Submissions Report

Monaro Rock Quarry

Development Application No. SSD- 27223807

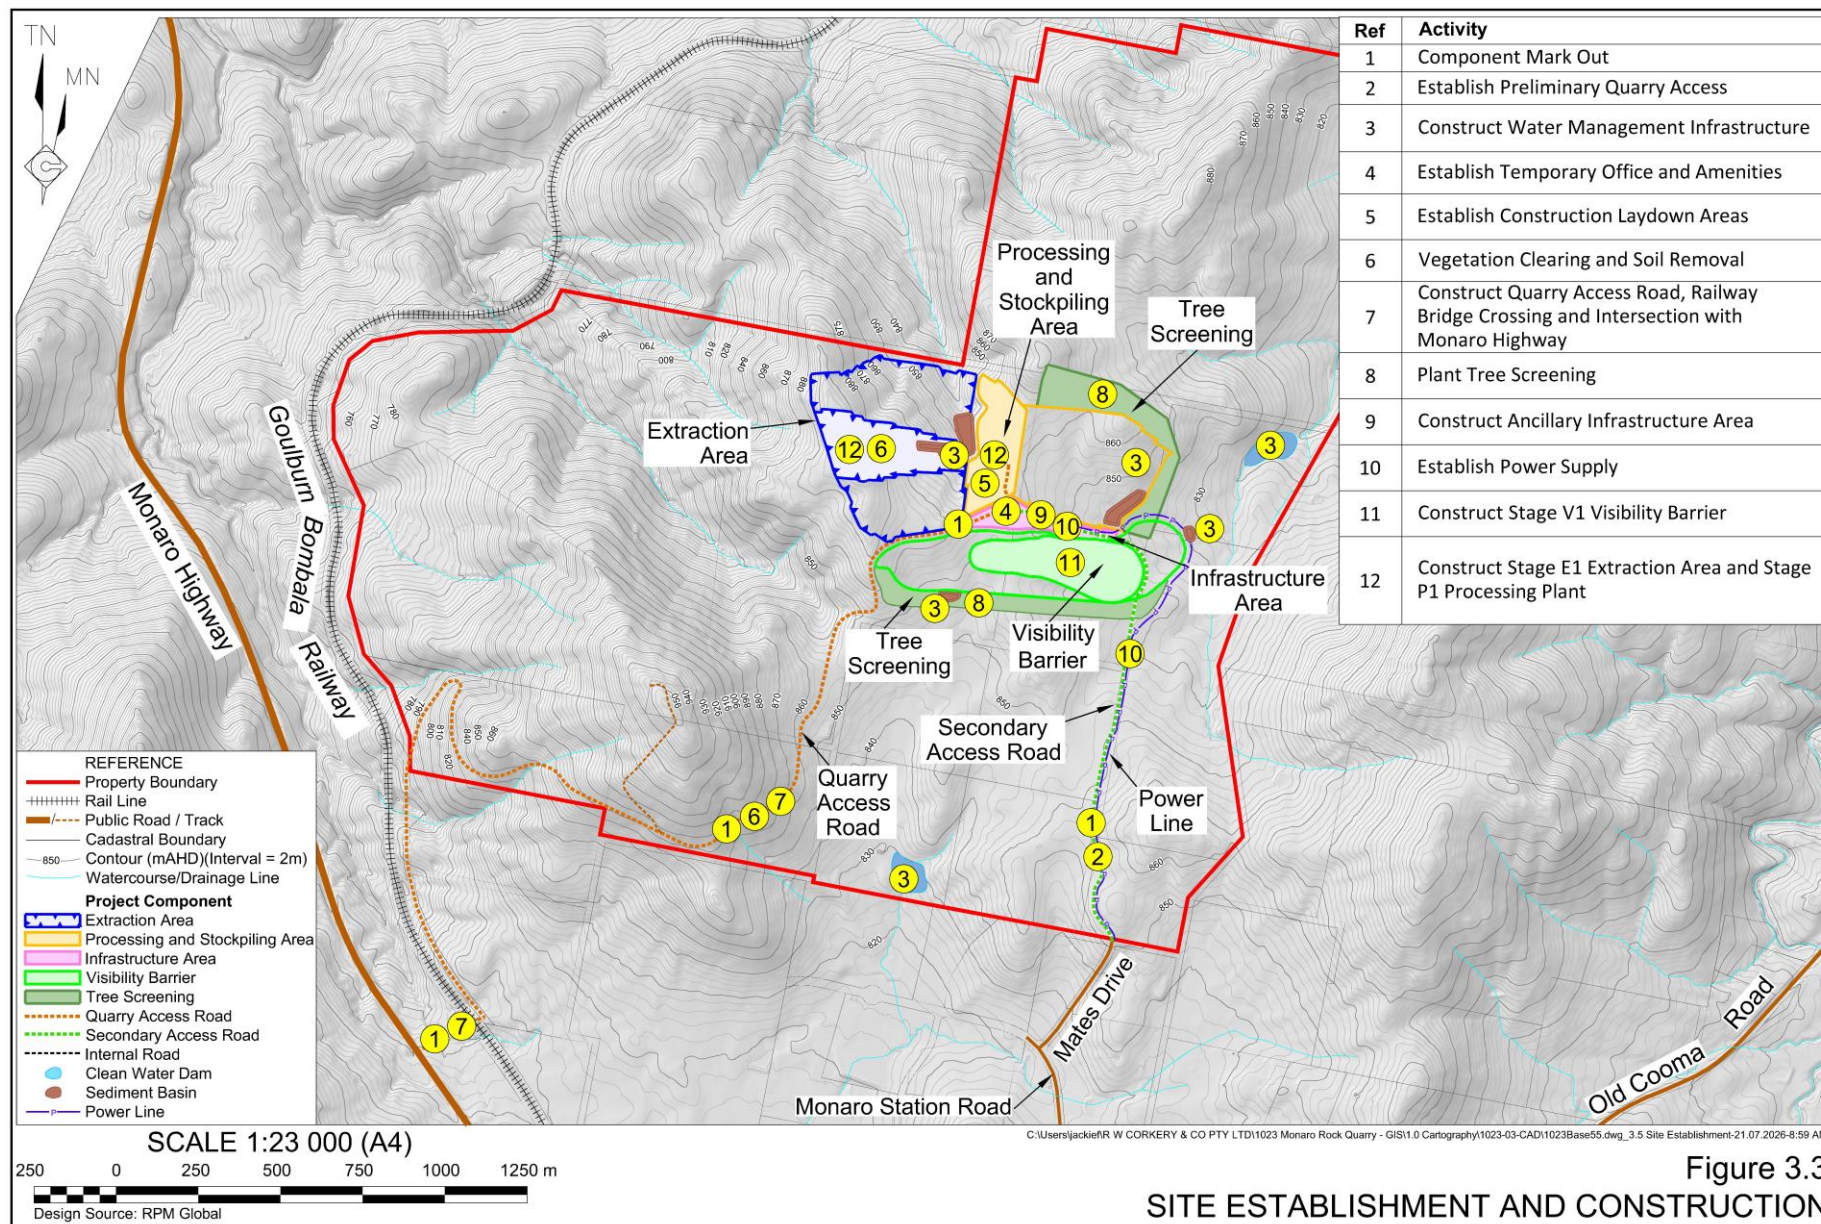
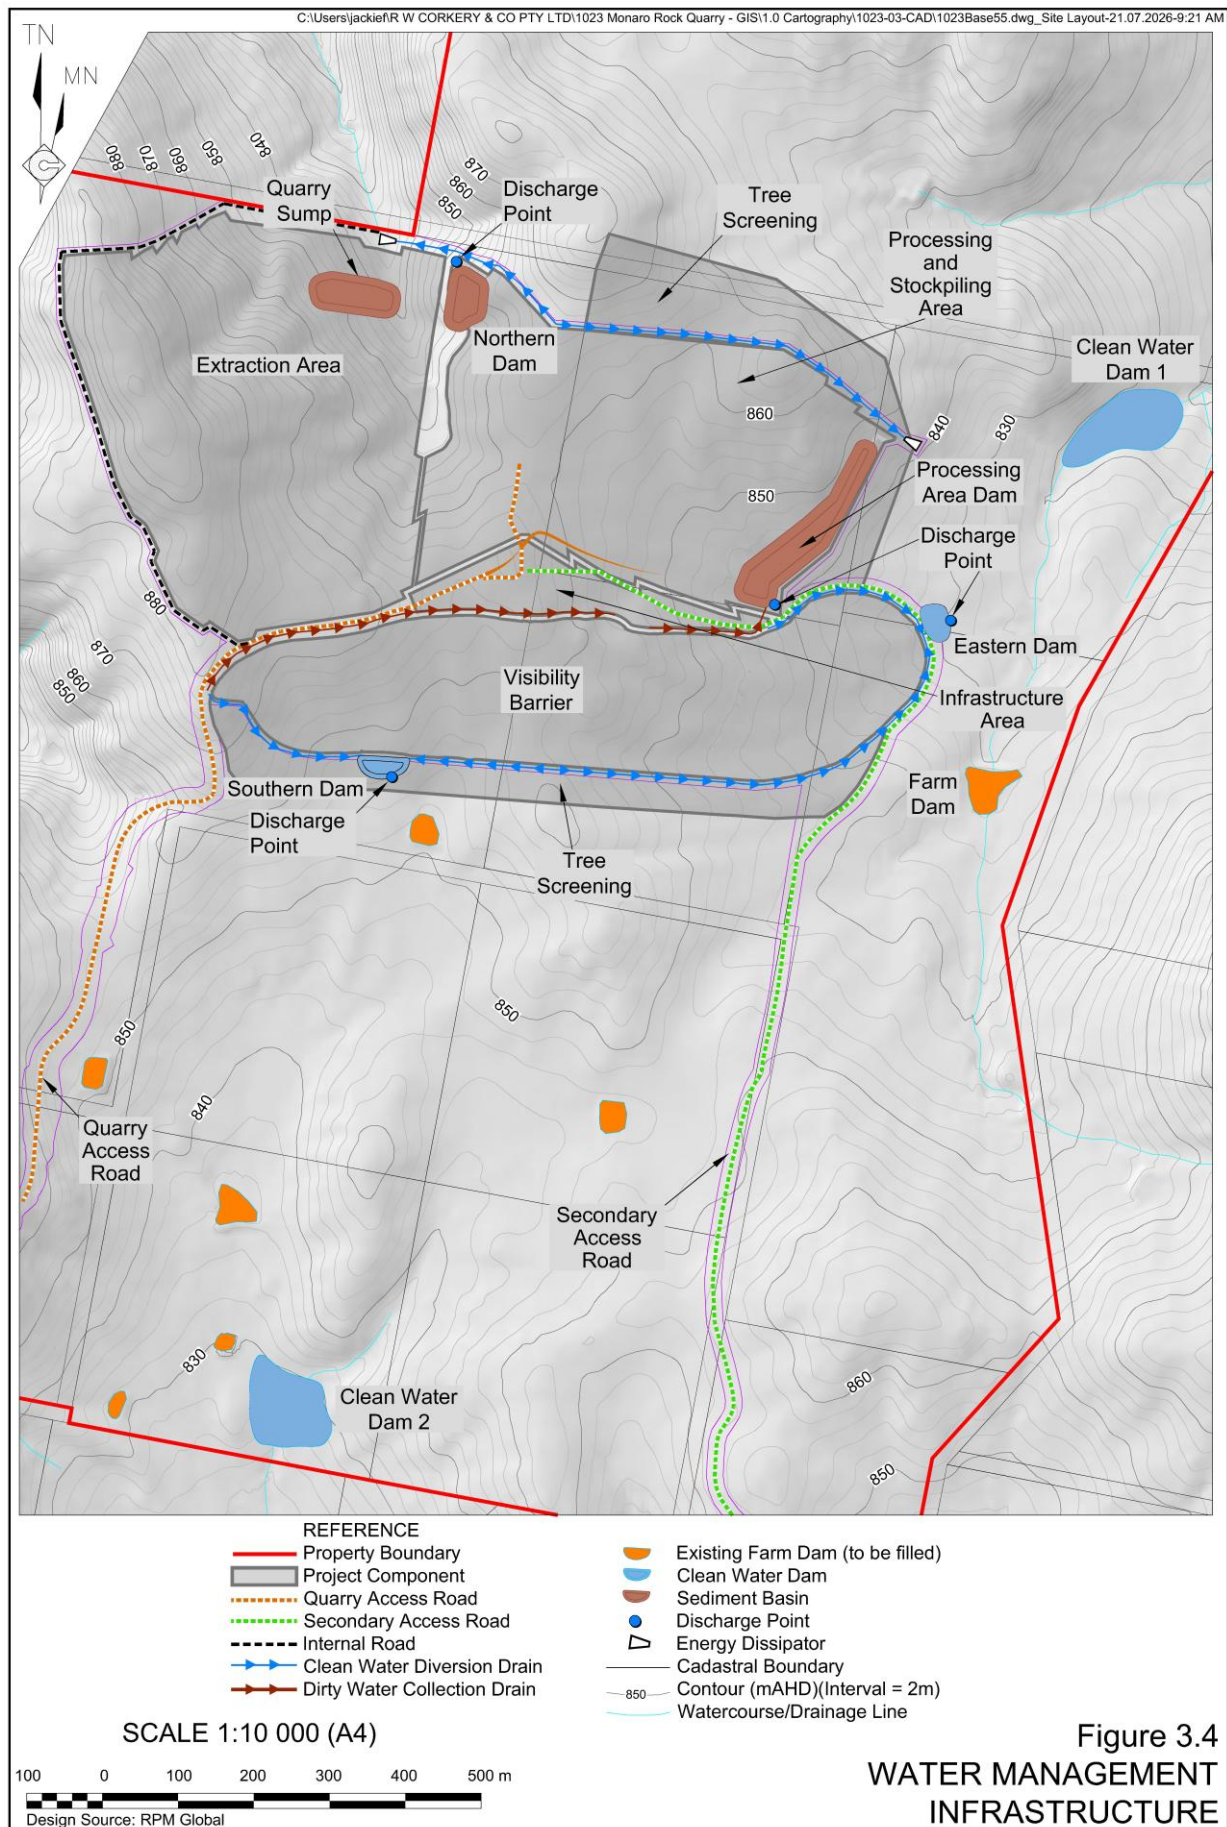
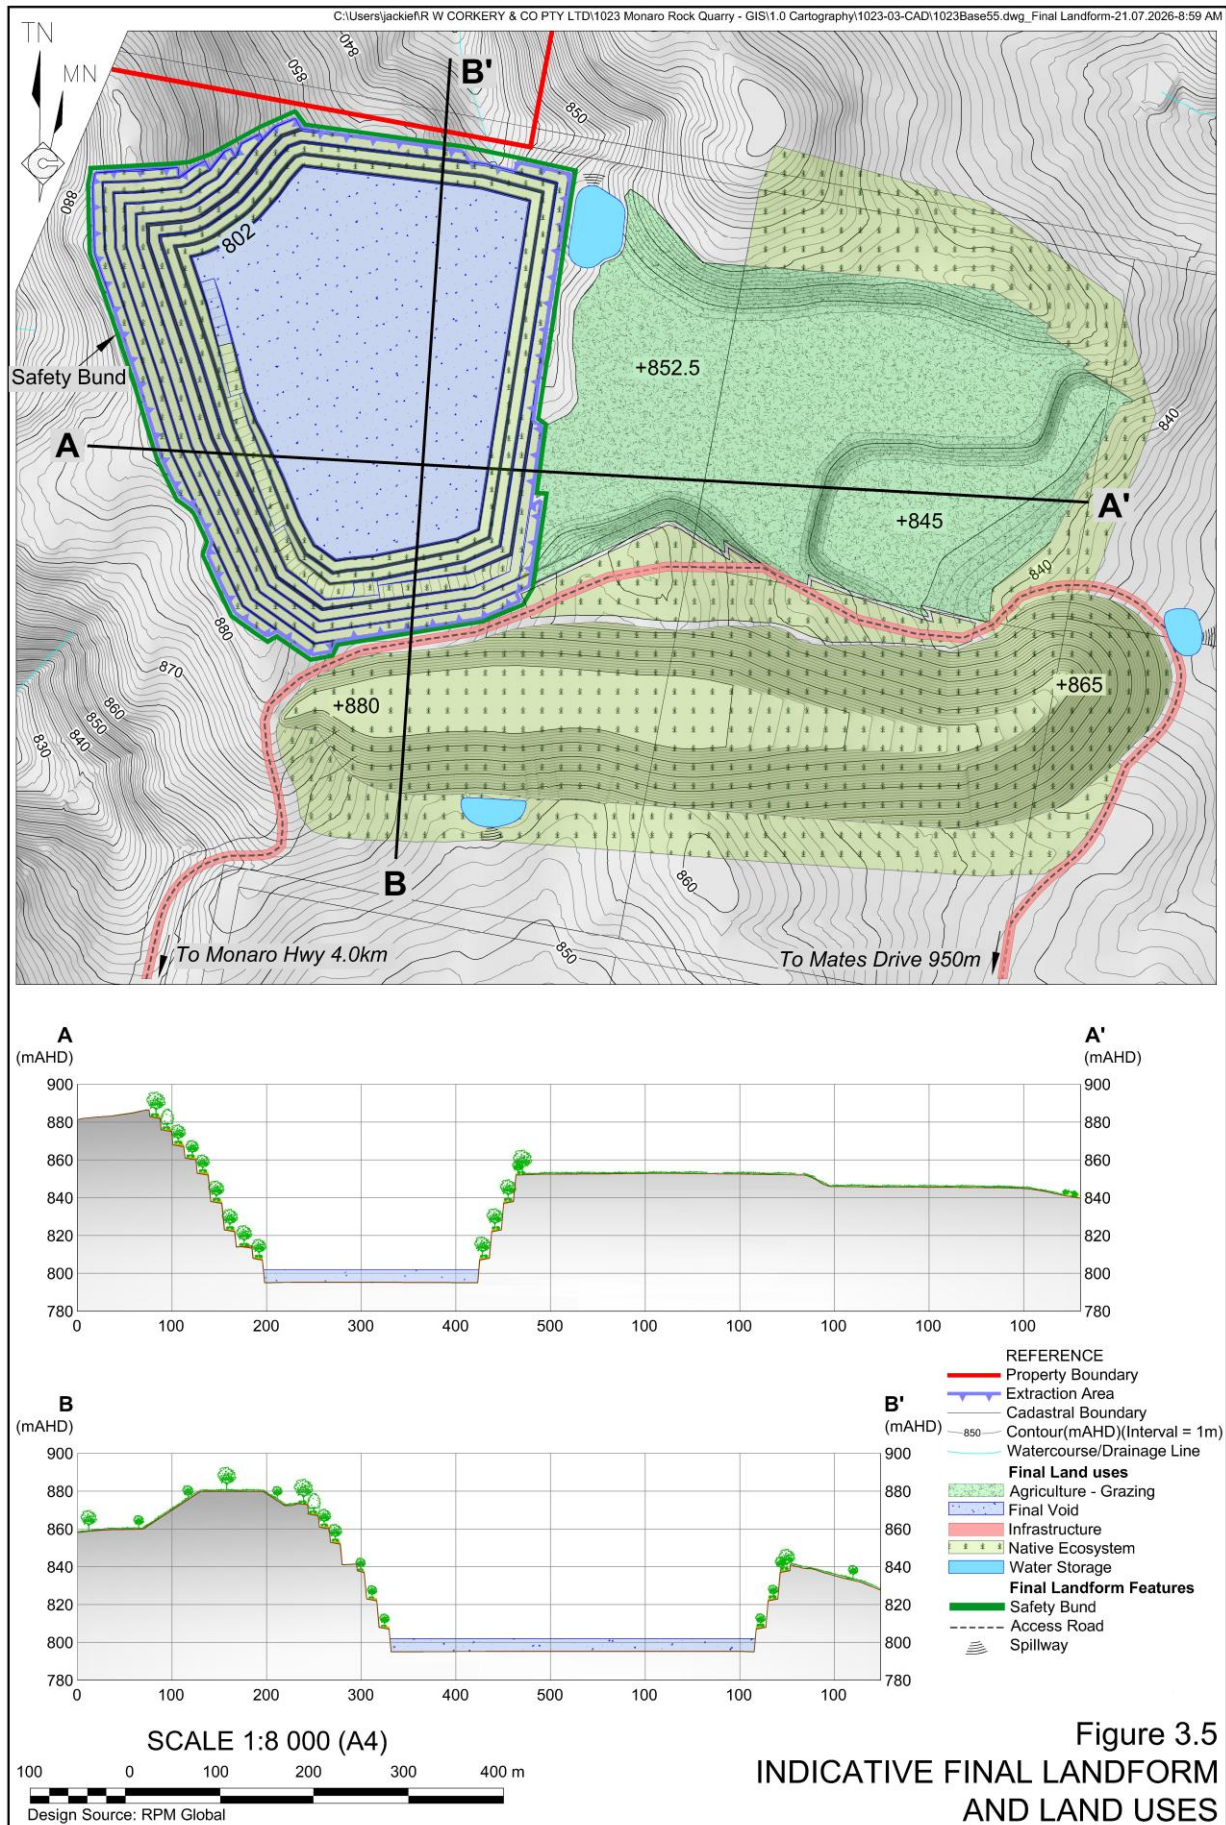
- The size of sediment dams to be constructed within the Processing and Stockpiling Area has been amended to provide a greater capacity for the Northern Dam and Processing Area Dam. This change was prompted by the EPA request that the Project water management infrastructure have the capacity to safely contain runoff from disturbed catchments from at least a 1 in 10 year (10% Annual Exceedance Probability) storm event. For the Project Site location this event represents 95.5mm of rain over a 24-hour period. Importantly, changes to the dam sizing does not change the physical disturbance or vegetation clearing required for the Project.

The updated sediment dam sizing has been incorporated into figures presenting key components of the Project as follows.

- Principal Project Components (including the sealing of the Secondary Access Road) - **Figure 3.1.**
- Project Site Layout - **Figure 3.2.**
- The schedule of site establishment and construction activities – **Figure 3.3**
- The general arrangement of water management infrastructure – **Figure 3.4.**
- The indicative final landform – **Figure 3.5.**
- Progressive rehabilitation for the Project – **Figure 3.6.**
- The progressive development of the extraction area (**Figure 3.7**) and processing and stockpiling area (**Figure 3.8**).
